**To:** Adriano Pupilli Architects  
**Project:** Newport Surf Life Saving Club  
**Report:** Access Assessment Report  
**Reference No:** 109261-Access-r4  
**Date:** 22/09/2020  
**Client Contact:** Adriano Pupilli  
**Email:** [ap@adrianopupilli.com.au](mailto:ap@adrianopupilli.com.au)  
**From:** Joshua Yeap  
**Direct:** 02 8484 4077  
**Email:** [jyeap@bcalogic.com.au](mailto:jyeap@bcalogic.com.au)

## EXECUTIVE SUMMARY

This document provides an assessment of the architectural design drawings for the proposed new development at Newport Surf Life Saving Club , against the Deemed-to-Satisfy provisions of the provisions relating to Access for Persons with a Disability.

Figure 2 – Double Door Leaf

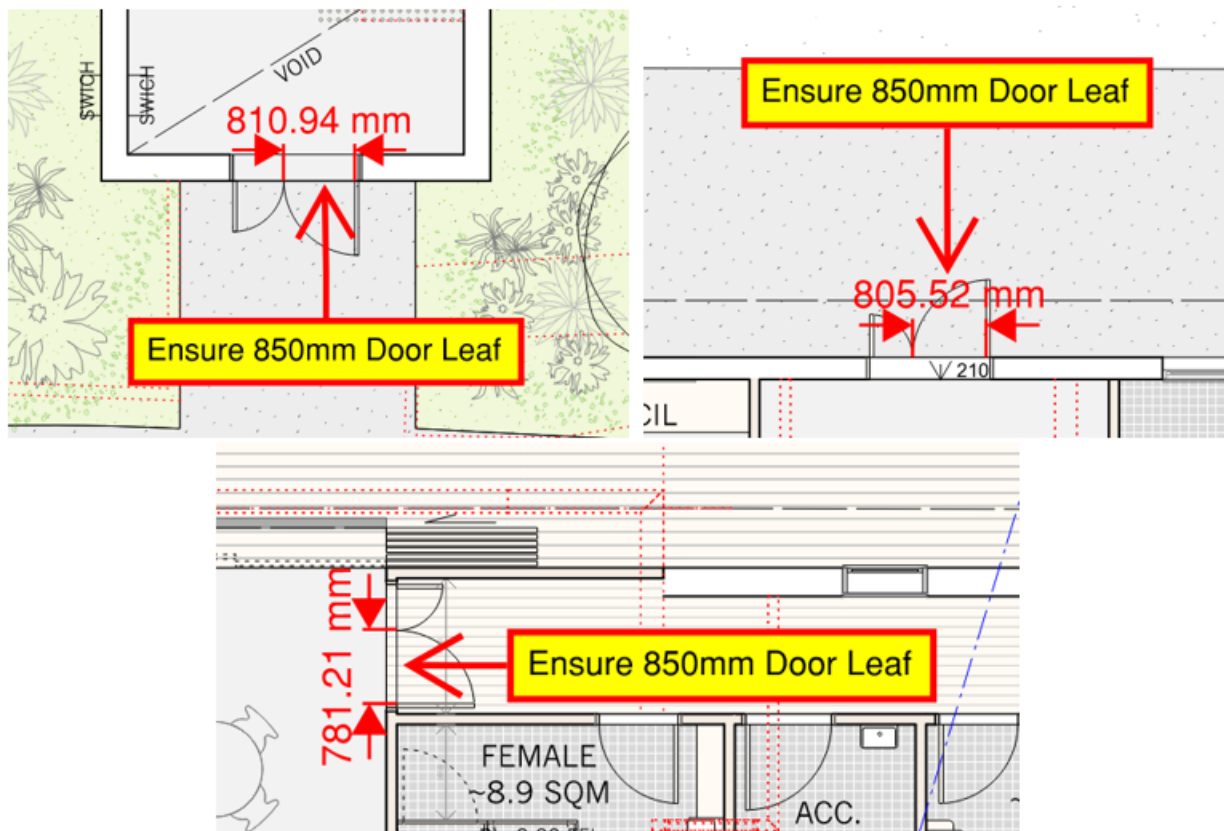
### Door Leaf to Double Doors

In accordance with the affected path of travel requirements of the Premises Standard, where double doors have been provided, the door leaf needs to be a minimum of 850mm as per AS 1428.1 Clause 13.2. The existing and proposed door leaves are assumed to be 850mm and will need to be reviewed during a detailed design review to assess if they need to be widened.

These are located to the entrance and exit on the Ground Floor and the entrance to the Lobby / Committee Room on Level 1.
